**H12093**

*Red, Bold, Italic comments made during office processing*

**Descriptive Report to Accompany  
Hydrographic Survey H12093  
Scale 1:20,000, Surveyed 2010  
*M/V Atlantic Surveyor*  
Science Applications International Corporation (SAIC)  
Charles F. Holloway, Lead Hydrographer**

**Project Number:** OPR-D302-SA-09

*Figure 1.2.1*

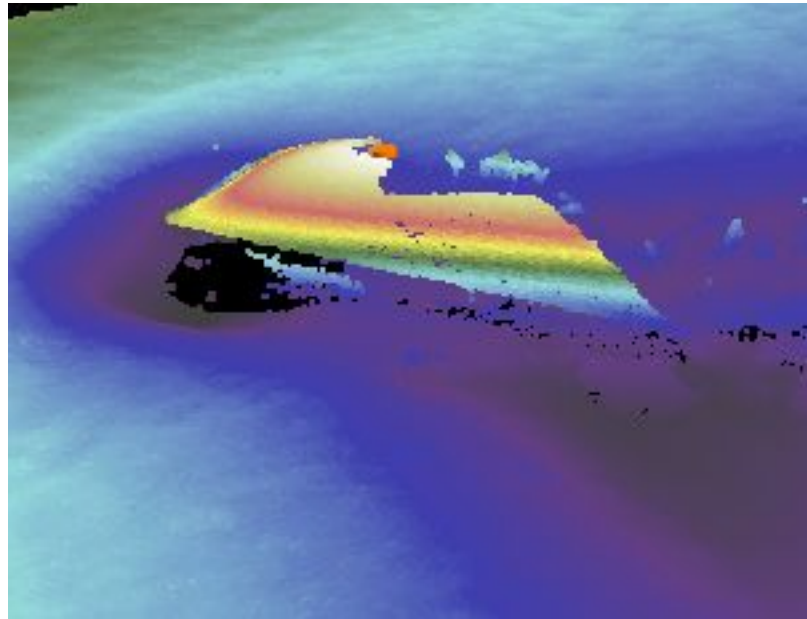
COMPILATION: Concur. Delete charted 44 foot dangerous sunken wreck. Add 47 foot dangerous sunken wreck in present survey location.

Figure 1.3.1

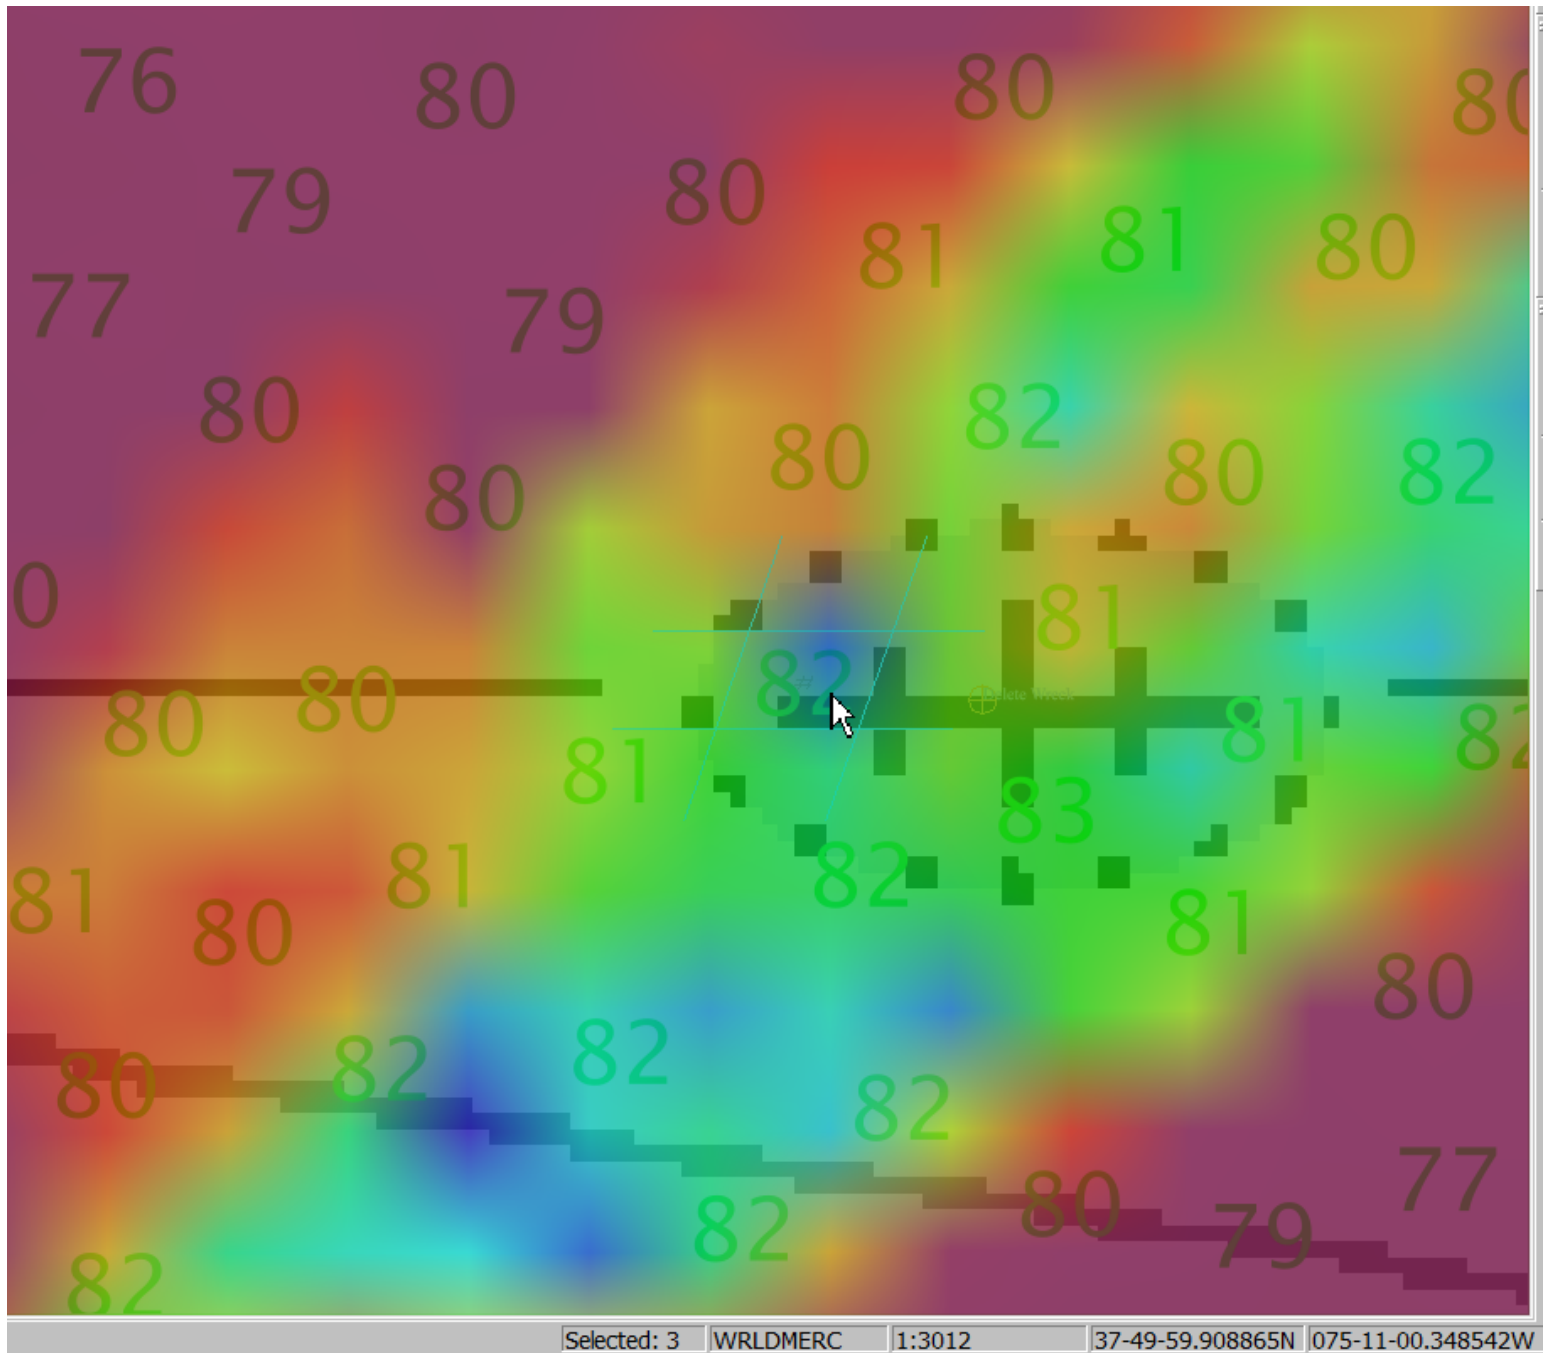
COMPILATION: Concur. Delete charted dangerous sunken wreck, depth unknown. Add non-dangerous 82 foot sunken wreck remains in present survey location.
